# SERVICE NOTE

54845A-10A

### 54845A Infiniium Oscilloscopes – 8Gsa/s, 4 Ch, 1.5Ghz

This Service note is providing instructions for an alternate repair strategy for 54845A Infiniium Scope, when the A13 54845-69527 Exchange board is not available. The 54845-69538 Exchange board can be used in substitution, but will require modification to give the 54845A Runt Trigger capability. The board once modified must be re-labeled to a 54845-69539 board, to track this modification of functionality

Figure 1

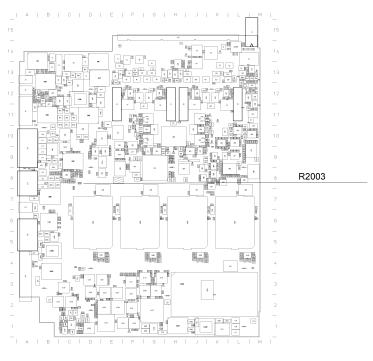
- 1. Per figure 1, add 0699-2643 0 OHM SMT resistor, to location R2003.
- 2. Re-label modified Acquisition Assembly to 54845-69539.
- 3. Upgrade unit application Firmware to A0.4.37, or higher.
